RE: LUMBER WAREHOUSE, 989 ROOSEVELT TRAIL

LUMBER WAREHOUSE
989 ROOSEVELT TRAIL
OCTOBER 12, 2018

Below are our responses to the email from Jonathan Earle, dated 10/11/12:

Pond 2P: INFILTRATION AREA

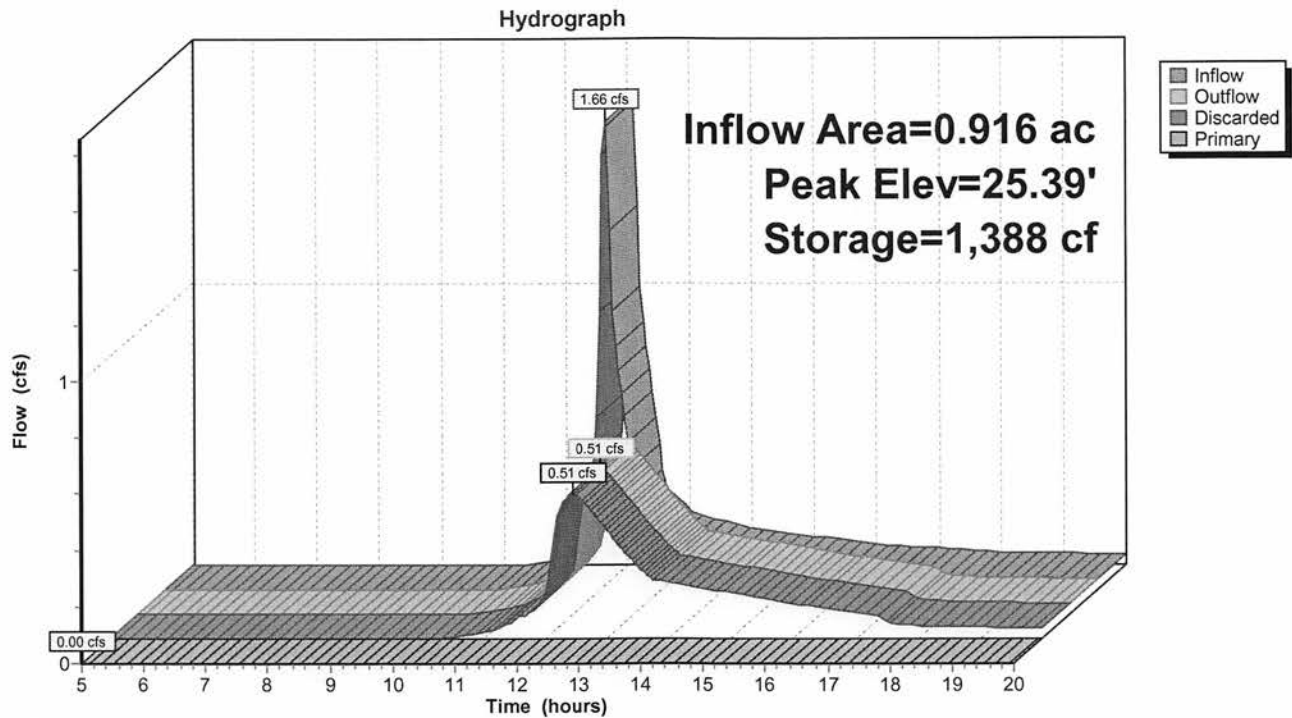
C. *Flooding Standard – The pre and post development stormwater plans and calculations have been reviewed. The plan shows one subcatchment tributary to the propose rock sandwich BMP. It appears a second analysis point should be considered at the northerly property line (near contour 323) to verify that the flooding standard is being met at this location.*

The soils on site are gravel, hydrologic soils Group A. All water infiltrates in the center of the site eliminating runoff from the parking area and Route 302. Calculations were considered unnecessary.
